DEVELOPMENT REVIEW BOARD REPORT

McDonalds Remodel Loc#02-0269 21-DR-2020	Request approval of the site plan and building elevations for a remodel of an existing restaurant with 4,930 square feet of building area on a 0.94-acre site.
---	--

21-DR-2020

SHEET NO.		SP2	
SITE PLAN		SITE PLAN

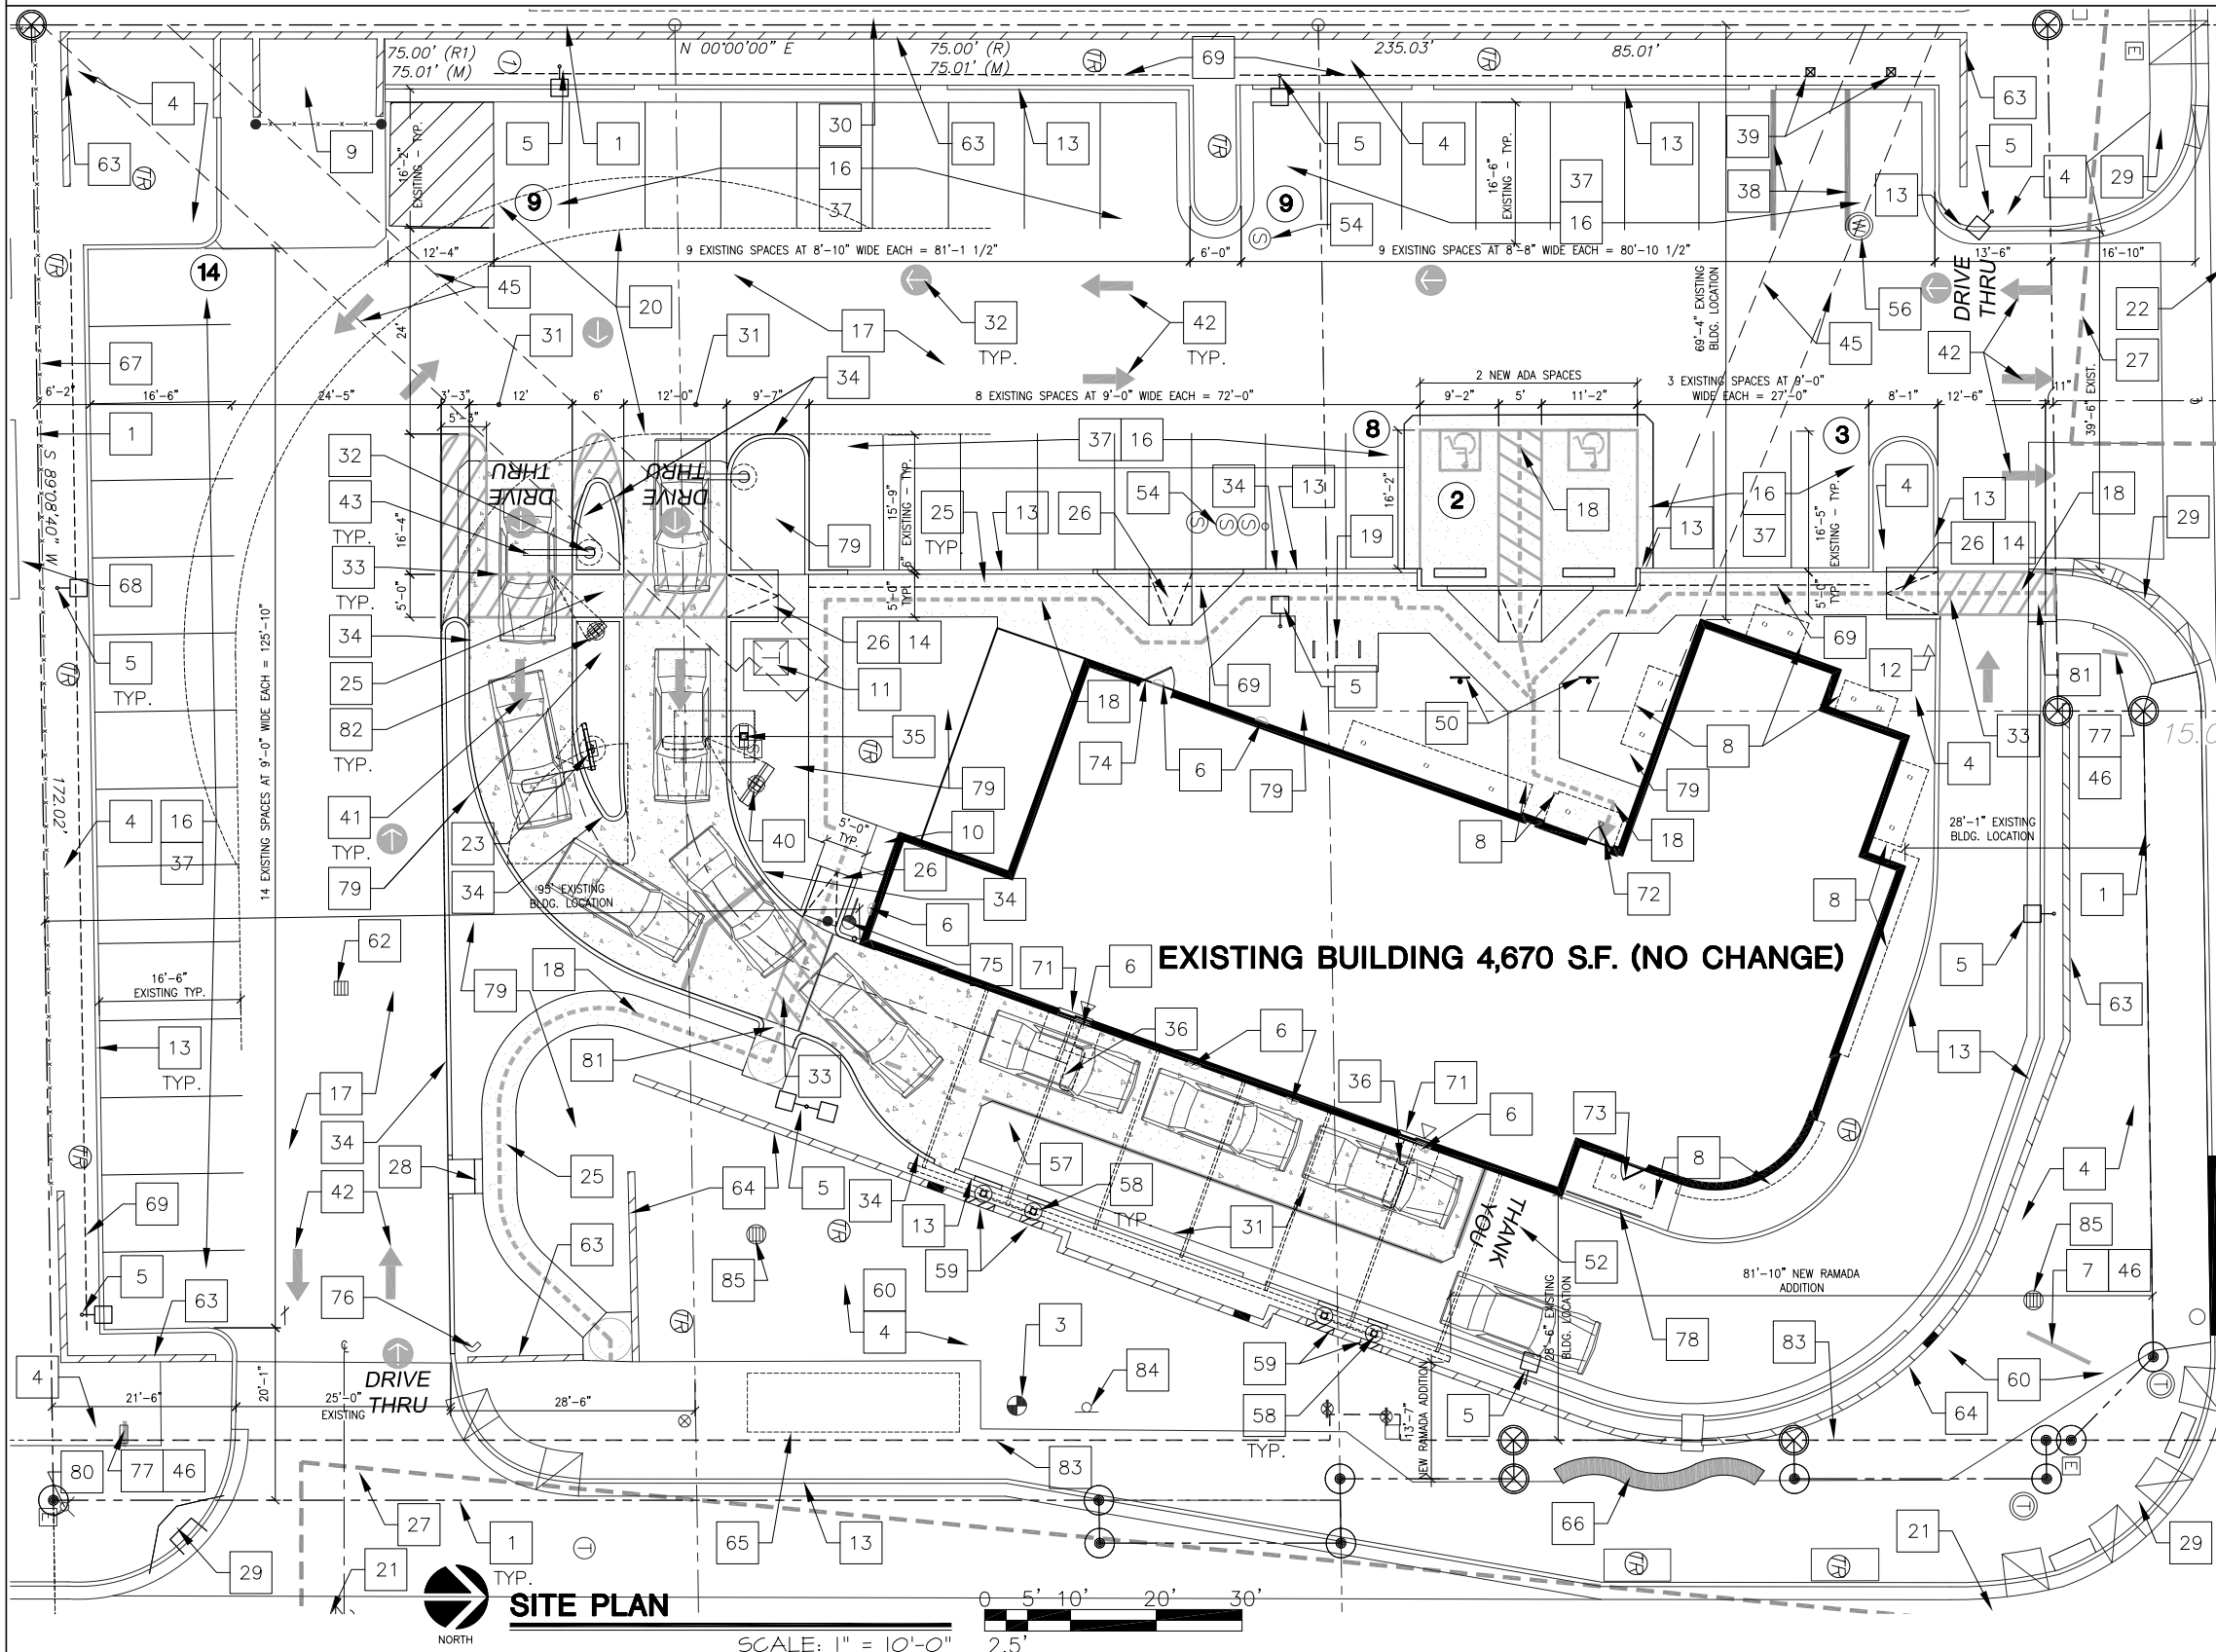
2. With the final plans submittal, section drawings of the proposed exterior shade devices, including the new shade canopy over drive-through shall be provided. All shade devices should be designed so that the shade material has a density of 75%, or greater, in order to maximize the effectiveness of the shade devices. This measurement is determined relative to perpendicular noon sun. The canopy over the drive through features tube steel purlins at a 15-degree angle that shall be revised to angle the purlins more to provide increased shade beneath the canopy.

1 **ELECTRIAL PHOTOMETRICES PLAN**
SCALE: 1" = 20'-0"

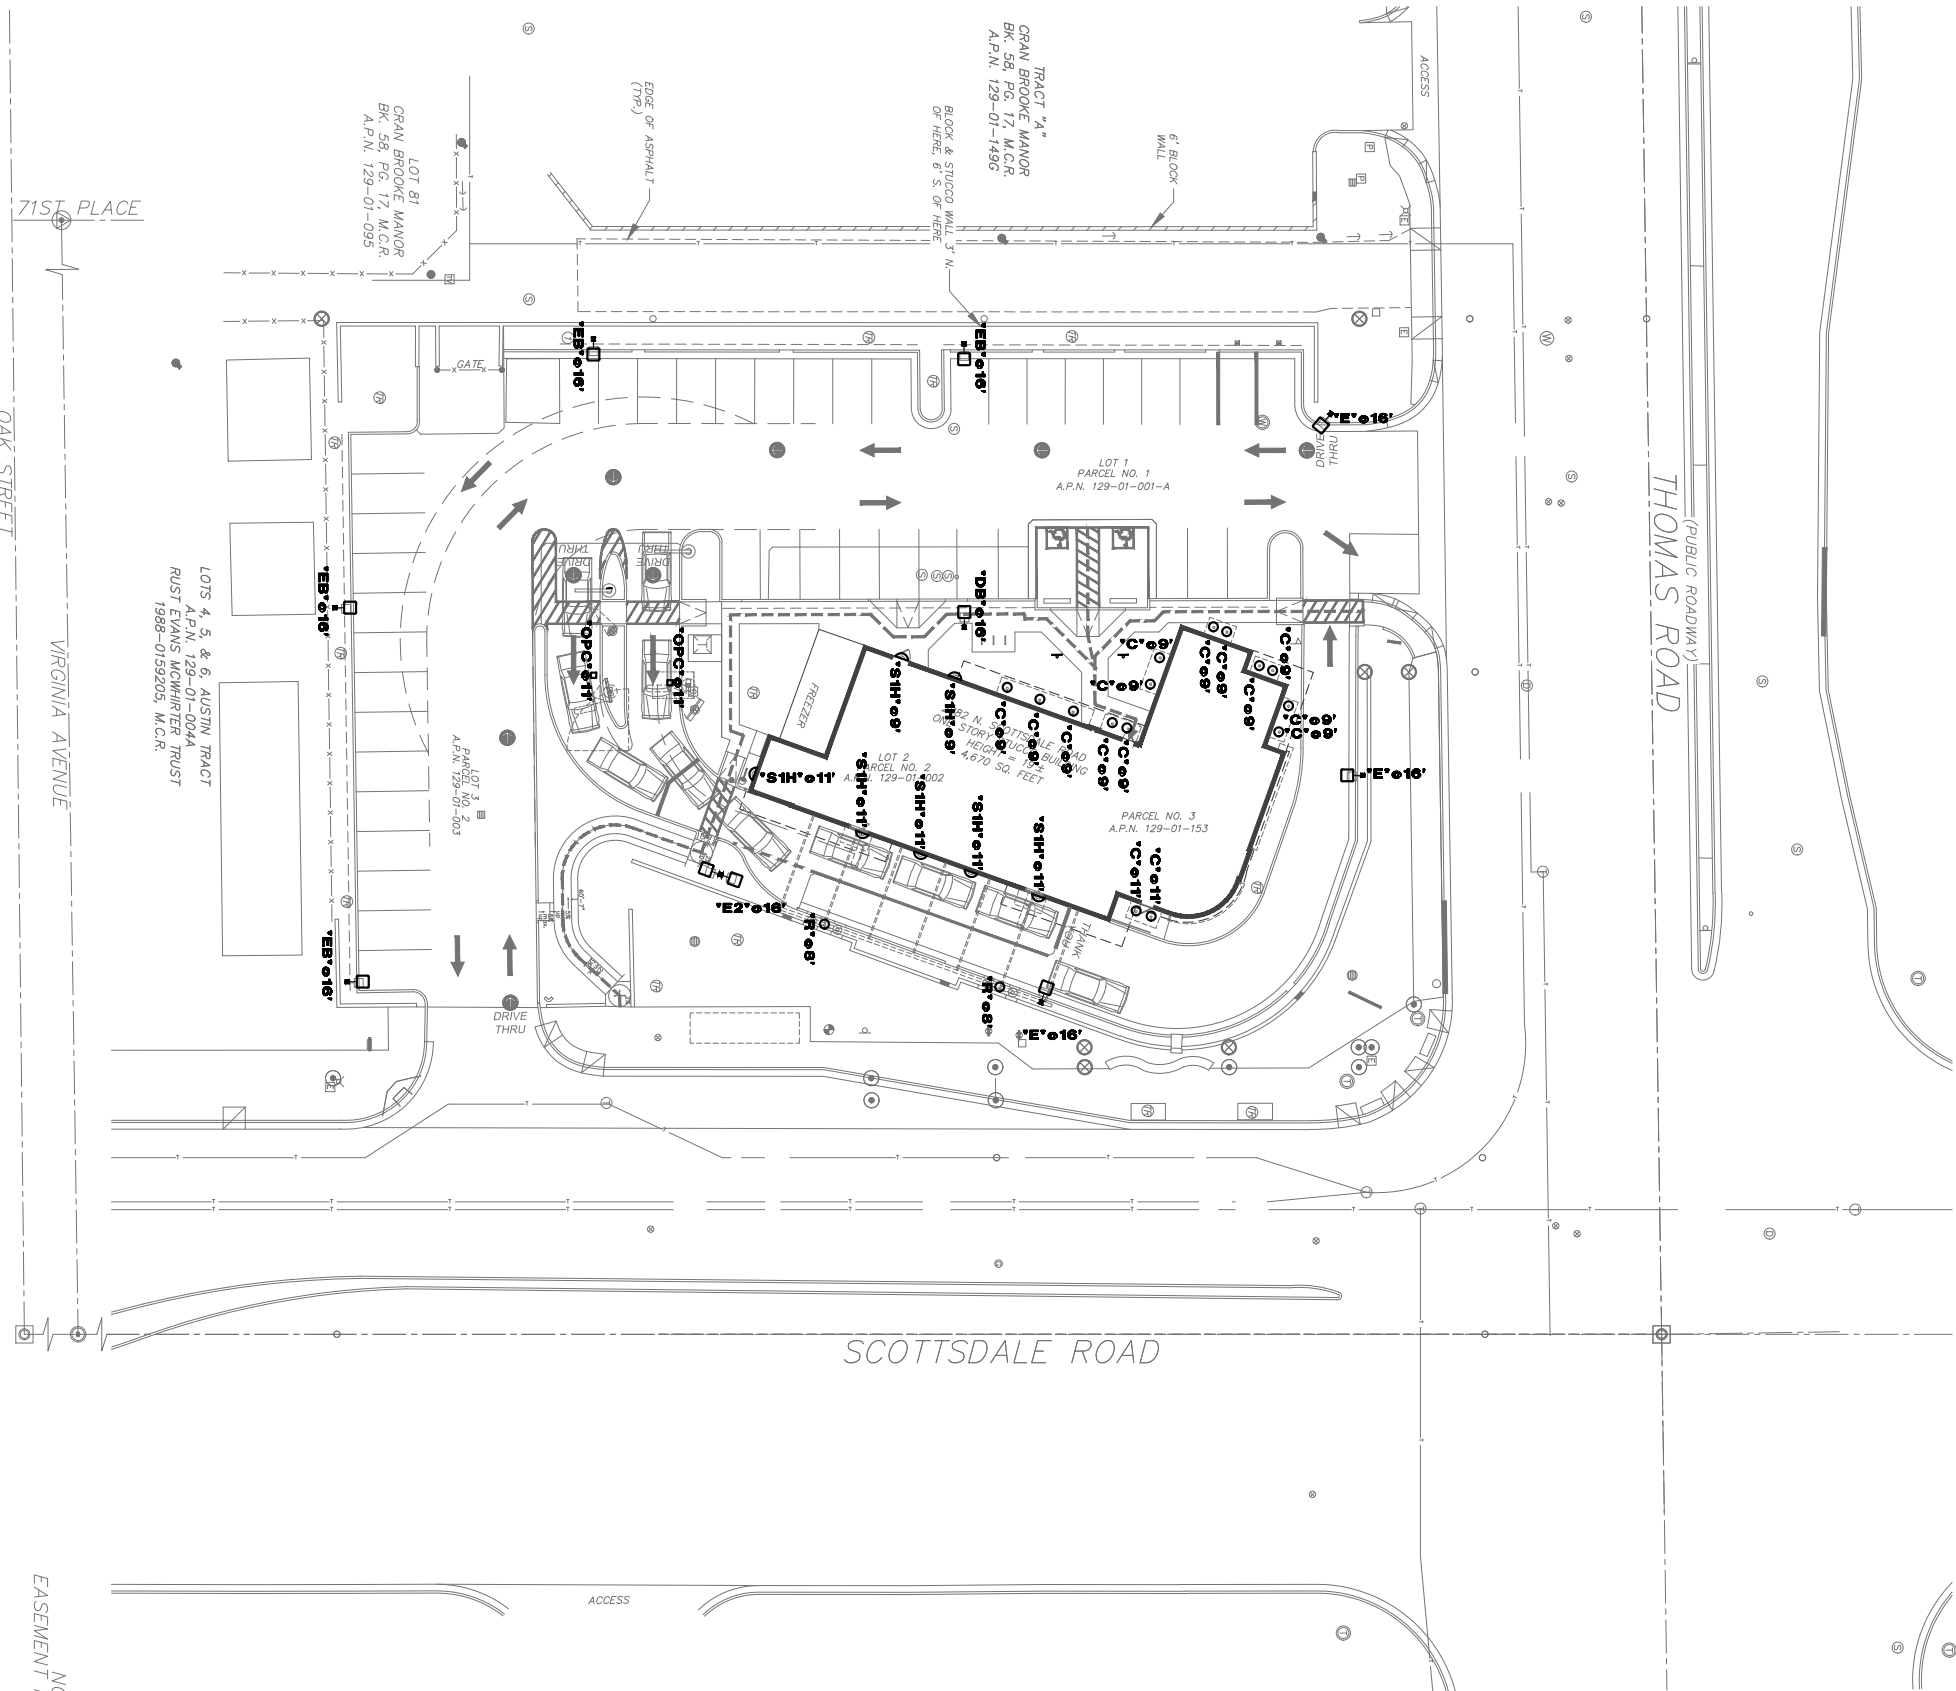
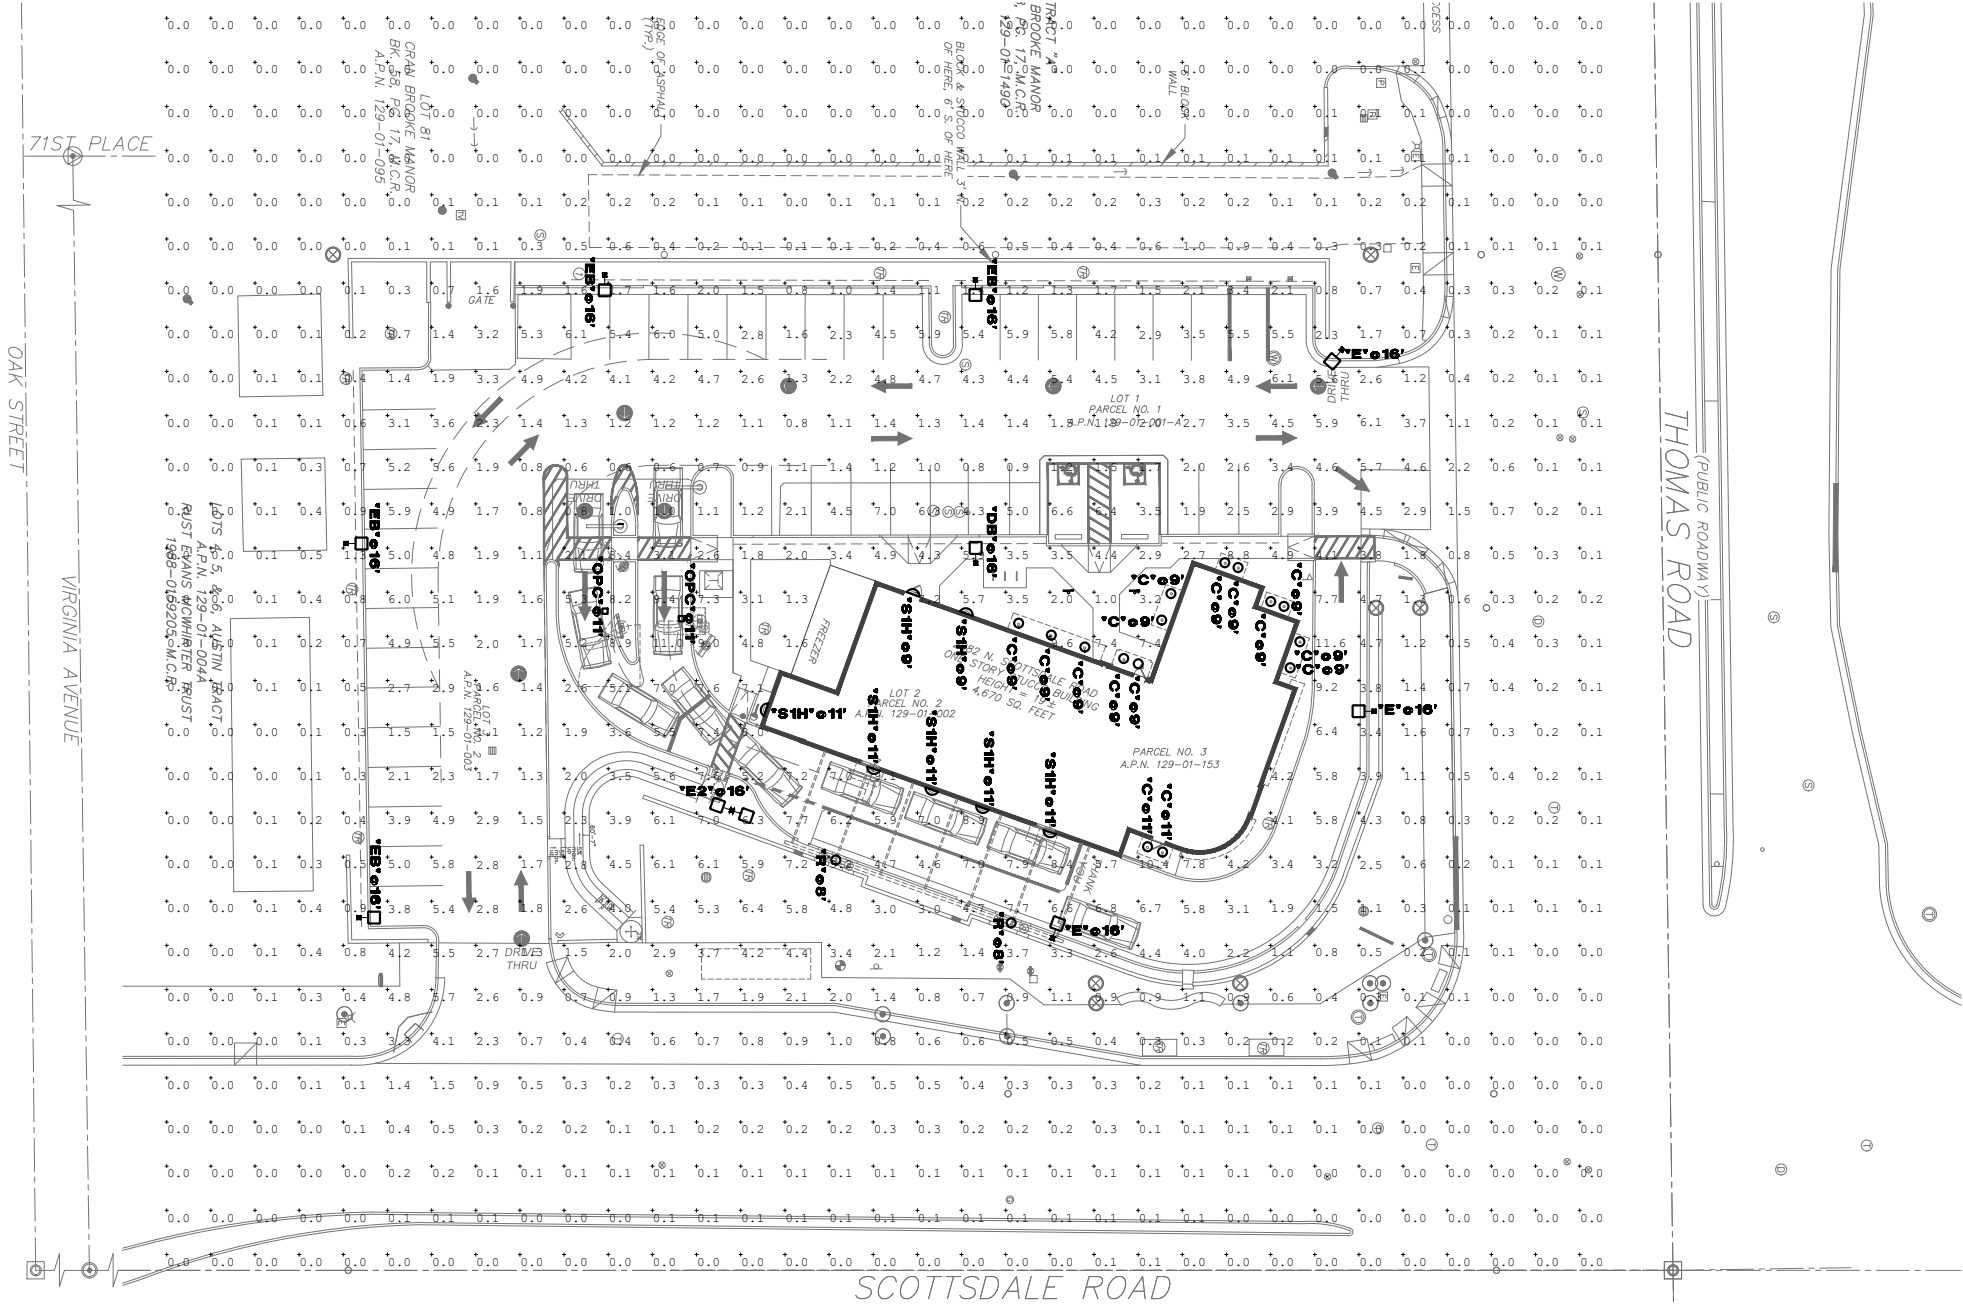
- 7. All fixtures shall provide a lighting color temperature of 3000K or less.
